Re: Bungarribee Industrial Estate – Metcash Distribution Centre and Offices (MP 10_0140) – response to submissions

Metcash, Huntingwood Drive

Bungarribee Industrial Estate, Huntingwood West Response to BCC Comments on Roundabout at Huntingwood Drive

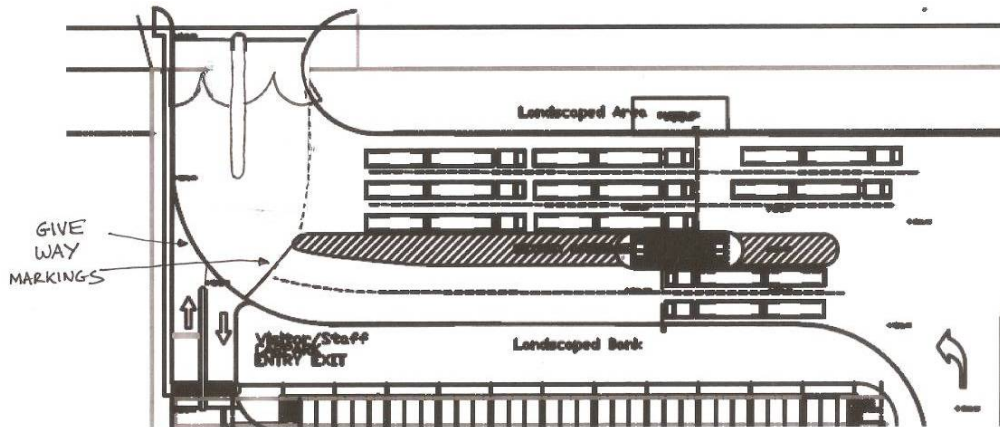
- (i) The proposal showed a shared driveway for both heavy and light vehicles to the western boundary of the site. The shared driveway is not supported as there is a conflict between trucks and cars near the car park entry ramp. It is our view that driveways must be separated to avoid conflicts between heavy and light vehicles. This could be achieved by providing truck access as part of the precinct plan roundabout between Lots 2, 3, 4 and 6 and retaining the western access point for cars only.

The potential of conflict between heavy and light vehicles near the car park entry ramp was considered during the design process. The more detailed proposal, which is not shown clearly on the submitted masterplan, involves a scheme to manage traffic priority at this location by means of give way intersection controls as shown on the sketch below.

The proposed layout will have the following features

- The location of the driveway relative to the gatehouse allows for a large number of B-doubles to park prior to the gatehouse, which gets them off the street network thereby not blocking cars wishing to enter the site / car park (*as is the case on other entrances on Huntingwood Drive to the east*)

- Trucks will be leaving the gatehouse via boom gates and then travelling at low speed before stopping at the Give Way line further west.
- The boom gates will not allow a continuous chain of B-Doubles exiting the gatehouse which means that cars will find adequate gaps to emerge from the car park.

- Cars leaving the car park will also be required to give way. They will need to give way when trucks are emerging from their Give Way line. This truck movement will be at low speed and therefore should not result in any adverse safety conditions.

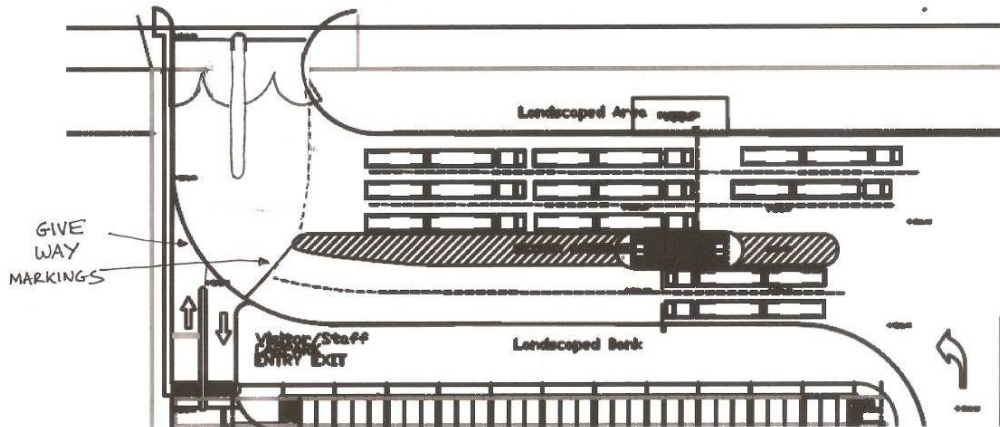
1. To eliminate vehicle conflicts between bicycles, light and heavy vehicles at the entry/exit to the site, the Department should consider requesting the applicant to redesign the entry/exit to separate heavy and light vehicles. This could be achieved by providing separate driveways for the car parking area and the heavy vehicle access.

The potential of conflict between heavy and light vehicles near the car park entry ramp was considered during the design process. However, it was considered that a single access point could cope adequately with all movements both in terms of traffic capacity and road safety.

The more detailed proposal, which is not shown clearly on the submitted masterplan, involves a scheme to manage traffic priority at this location by means of give way intersection controls as shown on the sketch below.

The proposed layout will have the following features

- The location of the driveway relative to the gatehouse allows for a large number of B-doubles to park prior to the gatehouse, which gets them off the street network thereby not blocking cars wishing to enter the site / car park (*as is the case on other entrances on Huntingwood Drive to the east*) – that accords with the RTA requirement that *'all vehicles will be contained within the site without being required to stop'*

- Trucks will be leaving the gatehouse via boom gates and then travelling at low speed before stopping at the Give Way line further west.
- The boom gates will not allow a continuous chain of B-Doubles exiting the gatehouse which means that cars will find adequate gaps to emerge from the car park.

- Cars leaving the car park will also be required to give way. Cars will need to give way when trucks are emerging from their Give Way line. This truck movement will be at low speed and therefore should not result in any adverse safety conditions.
